Subject: Planned Change Request for the use of Replacement Panels 11 and 12

Planned Change Request

for the Use of Replacement Panels 11 and 12

U.S. Department of Energy

Figure 1. Layout of Proposed Replacement Panels 11 and 12 (NMED 2023)

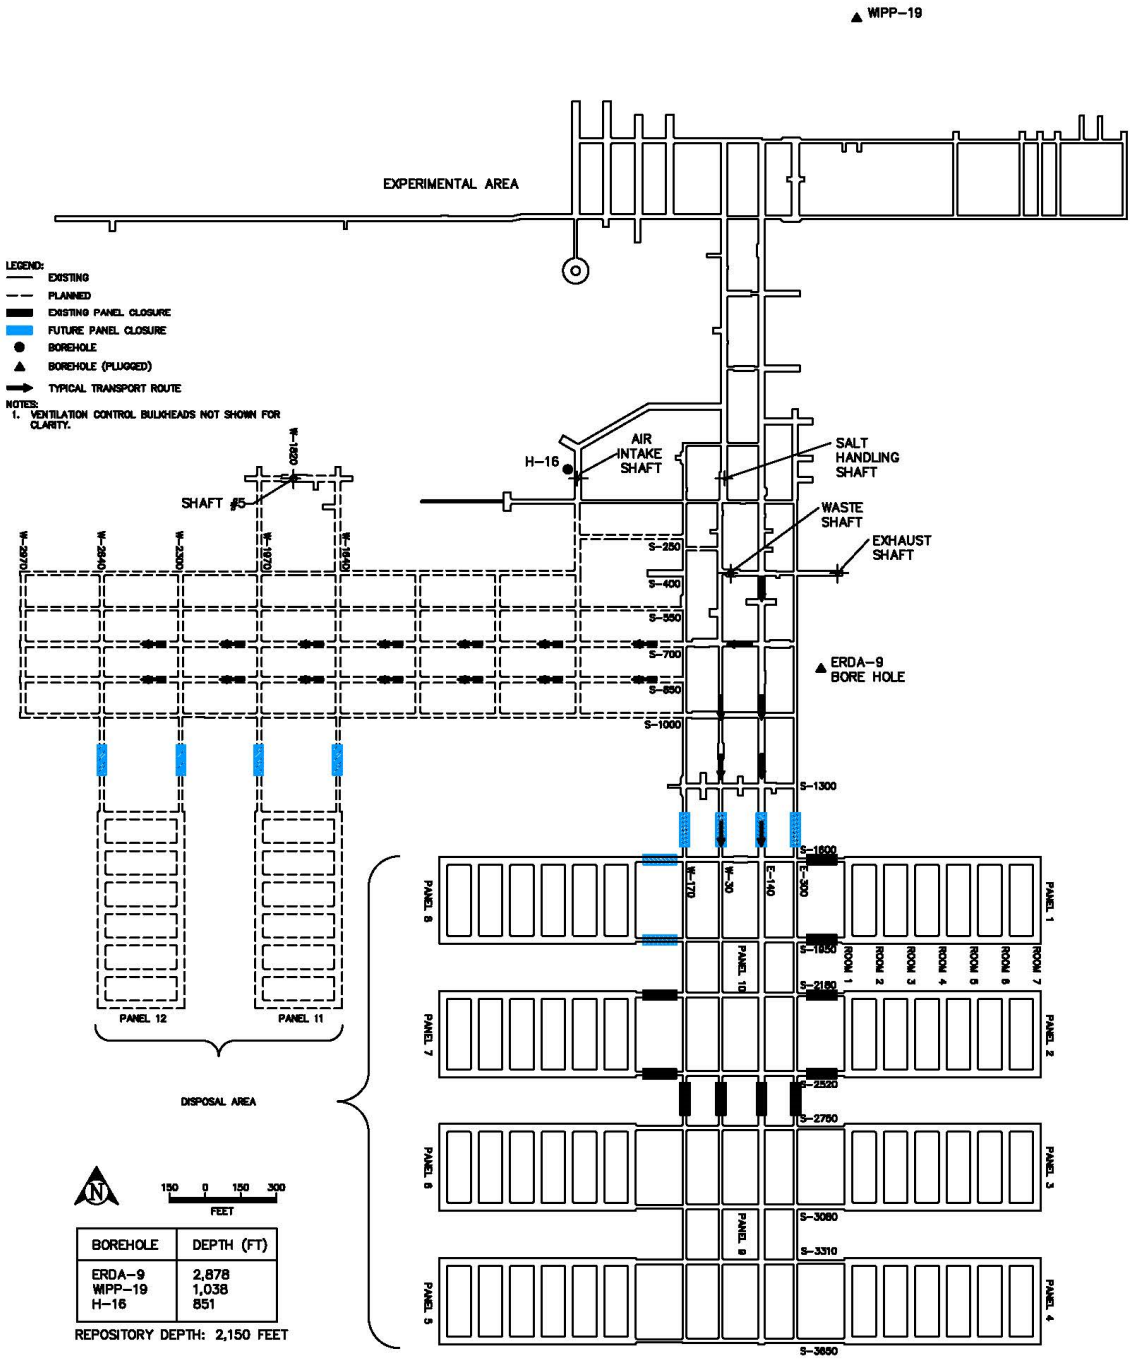
The replacement-panel layout (as illustrated in Figure 1) does not represent the WIPP repository's final configuration at closure, as the DOE has initiated an evaluation of up to seven "additional panels" (for a total of 19 panels) that may be necessary to dispose of the total TRU waste volume capacity limit authorized in the WIPP LWA. If the DOE decides to pursue the proposed action to construct and use additional panels, a future Planned Change Request (PCR) with the additional panel layout will be submitted to the EPA for review and approval.

The design for replacement Panels 11 and 12 is similar to Panels 1 through 8 (i.e., seven disposal rooms per panel). Replacement Panel 11 will be located to the south of the west mains at W-1640 and W-1970, and replacement Panel 12 will be located at W-2300 and W-2640 (Figure 1). Both replacement Panels 11 and 12 will be located within the same stratigraphic geologic horizon as Panels 1 through 8, approximately 2,104 feet (641 meters) below the surface.

Figure 2. Proposed Repository Layout (NWP 2020)

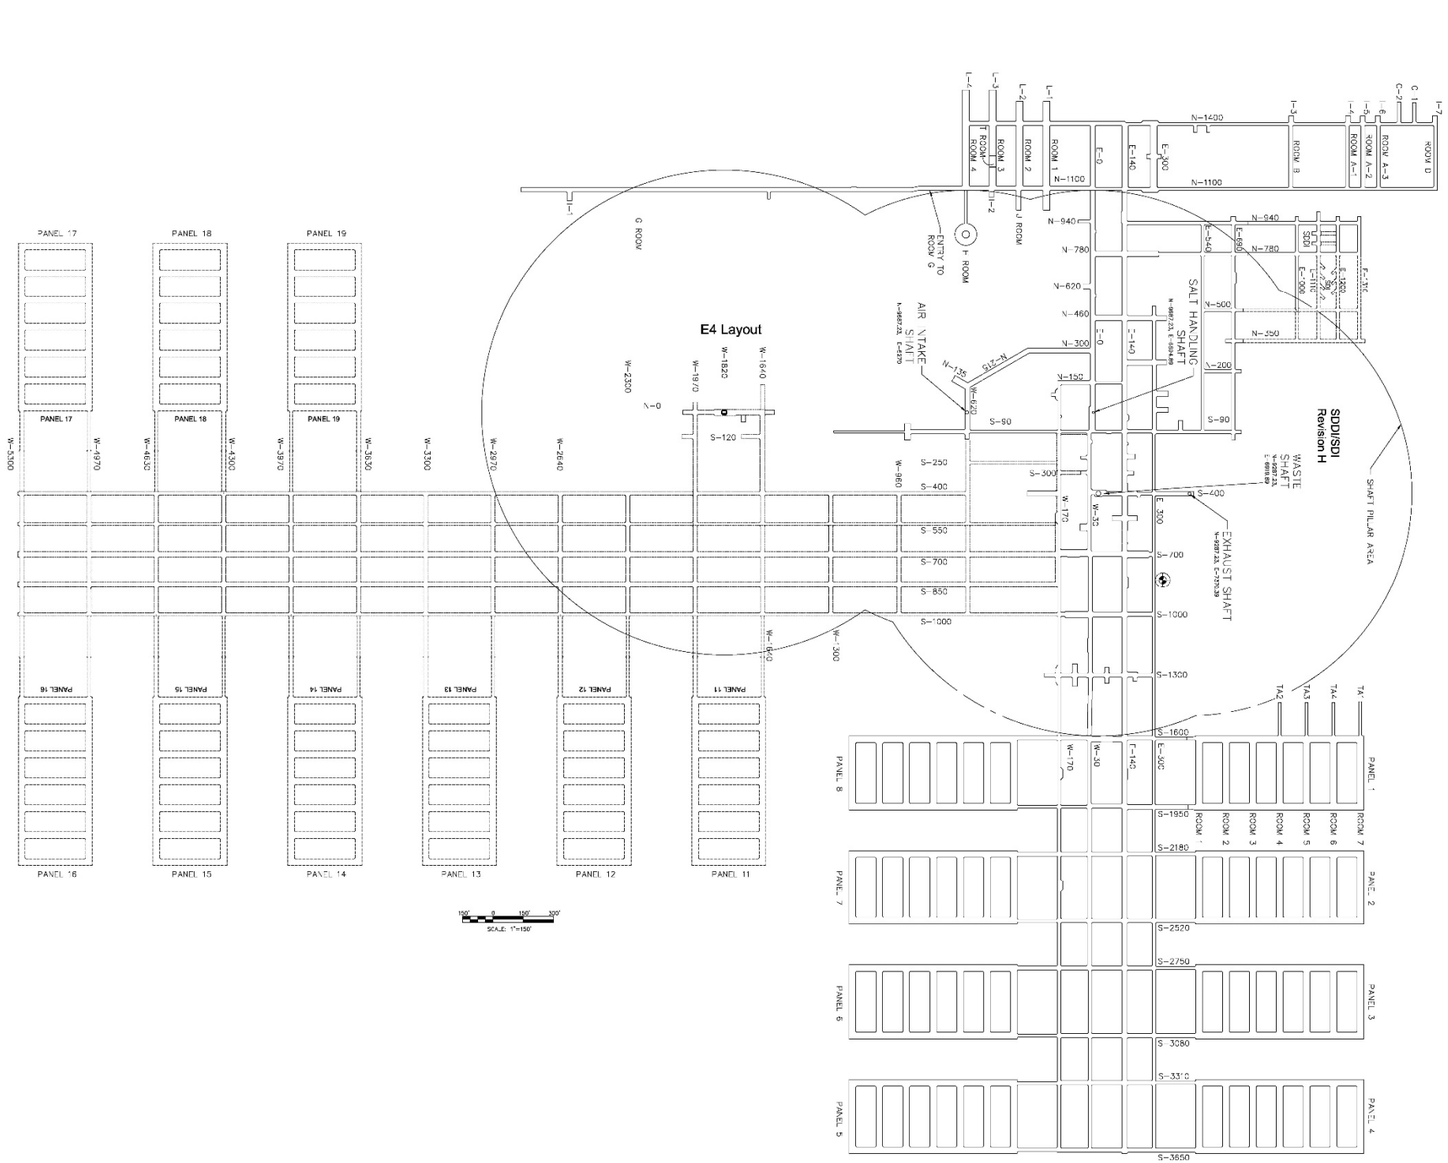
The repository is assumed to be filled to the LWA volume capacity limit by placing waste in the replacement Panels 11 and 12 and the additional Panels 13 through 19 (Figure 2). The assumption for a final facility closure date of 2083 is derived from the latest date a generator site plans to generate TRU waste (U.S. DOE 2022a). The DOE recognizes that there is uncertainty associated with a definitive closure date, and the generator-site completion dates for waste generation will evolve over the projected operational life of the WIPP facility (i.e., between now and 2083).

Figure 2-1. Current Repository Footprint and Proposed Replacement and Additional Waste Panels

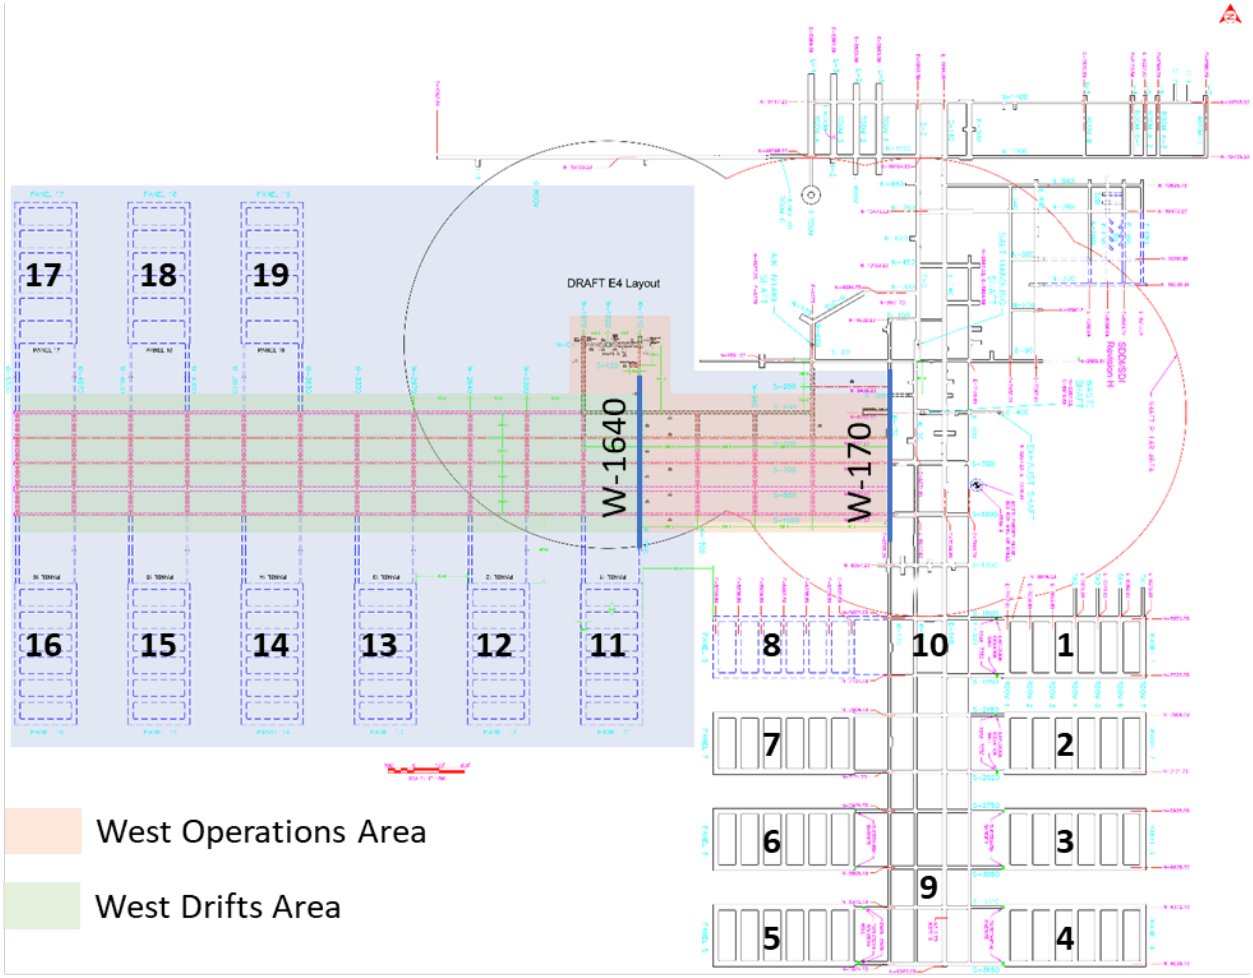
The DOE plans to excavate additional volume for waste disposal, comprising two replacement waste panels (numbered 11 and 12) and potentially seven additional panels (numbered 13 to 19) to the west of the current repository footprint (Figure 2-1, adapted from Sjomeling 2019). In the design used for this analysis, Panels 11 through 19 are similar to Panels 1 through 8, except that the abutment pillars (between the waste rooms and the access drifts) are increased from 61.0 m (200 ft) to 122.0 m (400 ft) and the isolation pillars (separating two panels) are increased from 61.0 m (200 ft) to 91.5 m (300 ft).

Figure 2-3. RPPCR Porosity Response Surface from Figure 3-8 of Vignes et al. (2023)

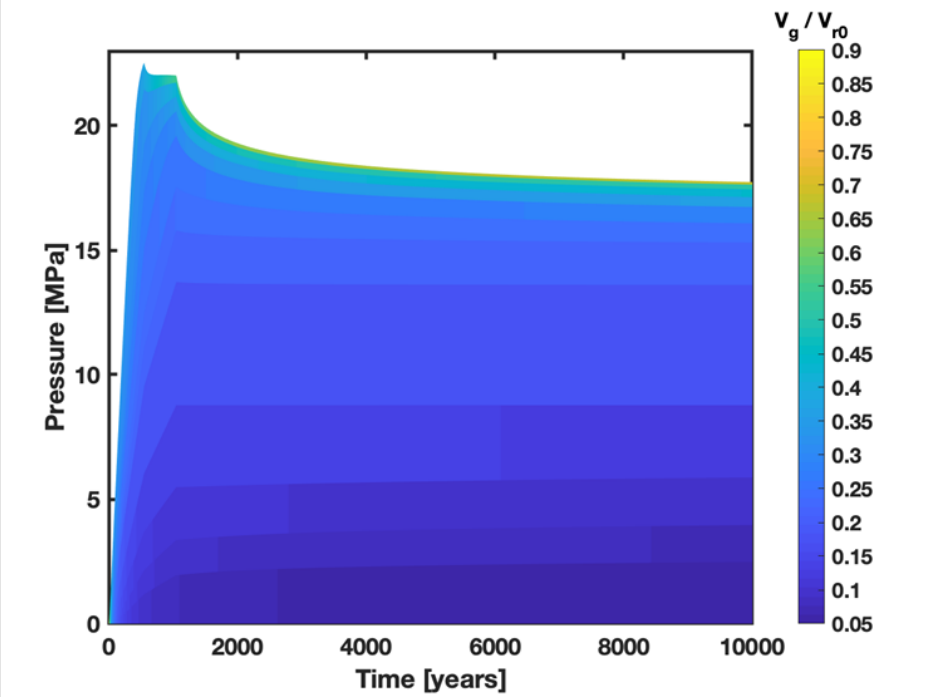
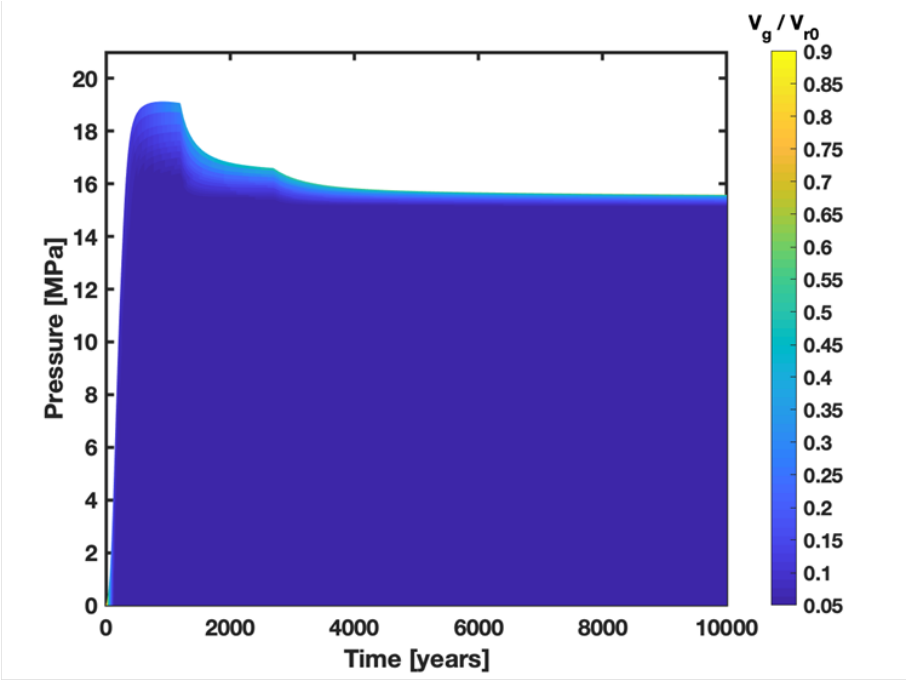
The legacy porosity response surface used in the CRA-2019 is shown in Figure 2-2. The updated response surface used in the RPPCR is shown in Figure 2-3. Of note for the Salado flow solution, at low pressures the porosity is lower for the RPPCR as compared to the CRA-2019. The two porosity surfaces have different shapes that will lead to different behaviors in the Salado flow simulations. Qualitatively, adding gas (going to higher f-curves) tends to have a response in both

pressure and porosity in the legacy surface. In the new surface, the primary response of adding gas below the range of lithostatic pressure of about 15 MPa is to raise the pressure. Once the pressure is close to lithostatic, adding gas will primarily result in an increase to porosity. See Vignes et al. (2023) for a discussion on the development of the new porosity response surface and see Section 4.2 and King (2023) for a discussion of the effect on the Salado flow results.

Figure 3-3. RPPCR DBR Grid with Simulated Intrusion Locations (Docherty and King 2023)

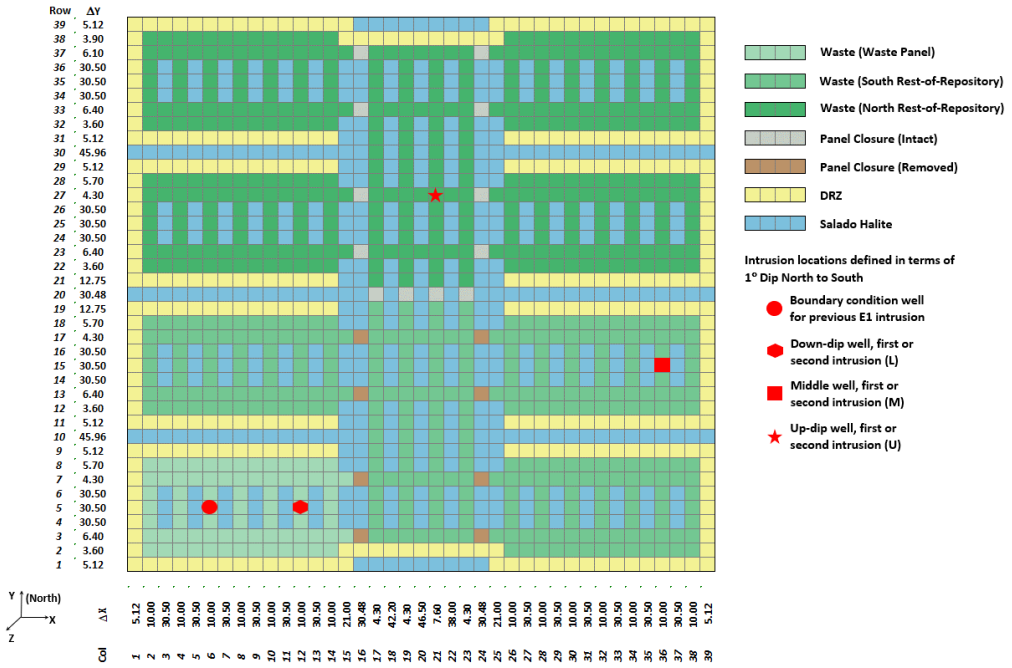
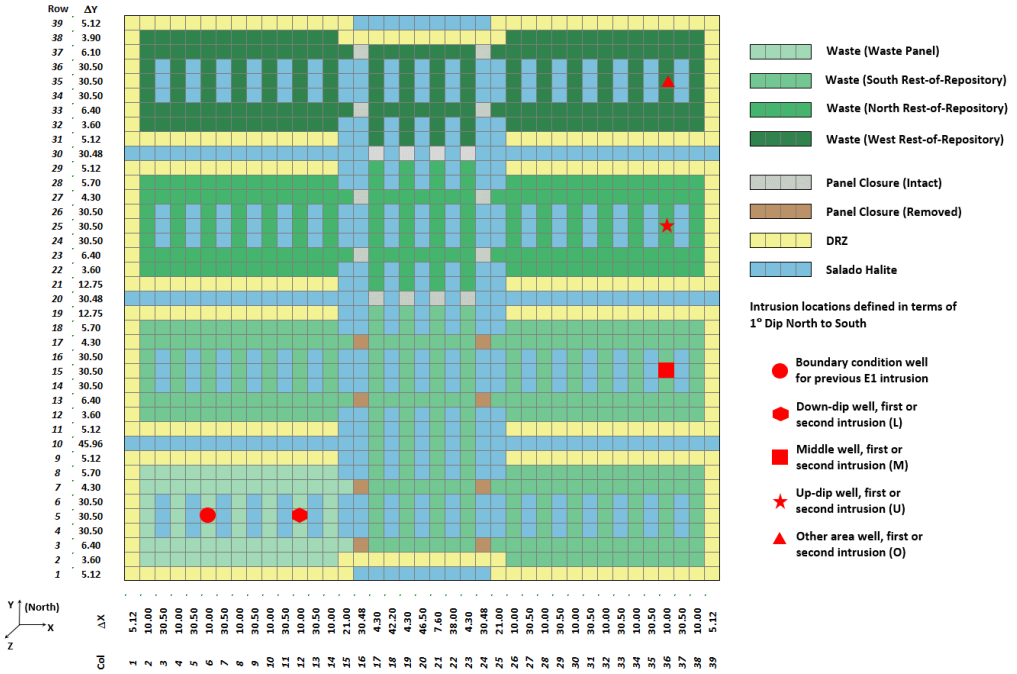
The DBR numerical grid and material map used in the CRA-2019 PA calculations are shown in Figure 3-2 and the DBR numerical grid and material map used in the RPPCR calculations are shown in Figure 3-3.

In addition to the three drilling locations considered in the CRA-2019 PA, a fourth intrusion location is considered in the RPPCR. An "O" (for other) intrusion location has been added to the existing locations "U" (for upper, since it is up-dip), "M" (for middle), and "L" (for lower since it is down-dip). These intrusion locations are shown in Figure 3-3. The calculations for scenarios S2-DBR and S3-DBR (Section 3.5.3) represent a drilling intrusion preceded by an E1 intrusion in either the same or a different waste panel. The effects of a prior E1 intrusion are incorporated into the calculations by specifying pressure at a boundary condition well, denoted by the red oval in Figure 3-2 and Figure 3-3.
